**Permit Application Review Report**  
**Date: 1/21/2026**

**Project Name:** River Edge Business Center

**Project PAN:** P-25-039

**Project Purpose:** Redevelopment of a commercial building, parking and associated stormwater management features

Figure 4: Floodplain Impact

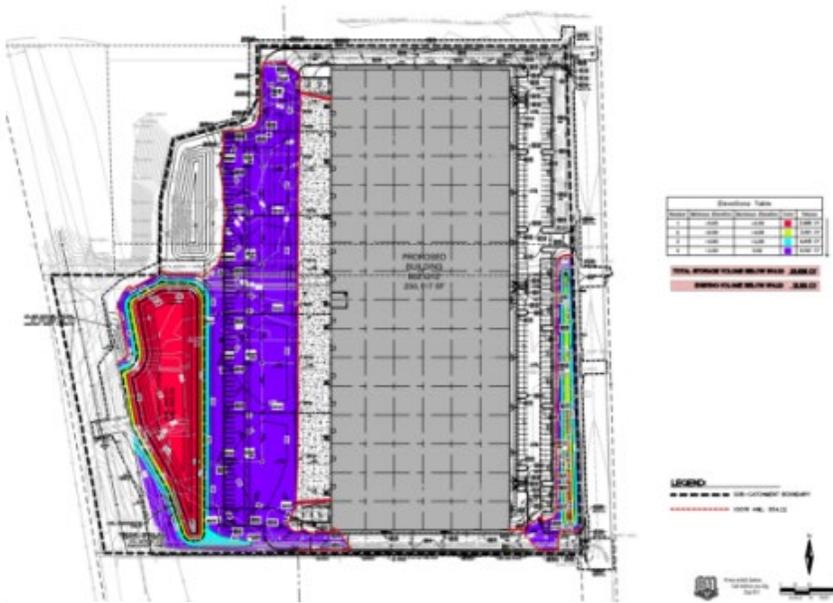
The regulatory floodplain elevation is 854.22 ft NAVD 88. Compensatory storage is required. The existing flood storage is 12,133 cubic yards. The proposed flood storage is 23,086 cubic yards. The proposed project provides 10,953 cubic yards of additional compensatory storage, which exceeds the required 1:1 ratio and is within the relevant reach. See attached Figure 4: Floodplain Impact.
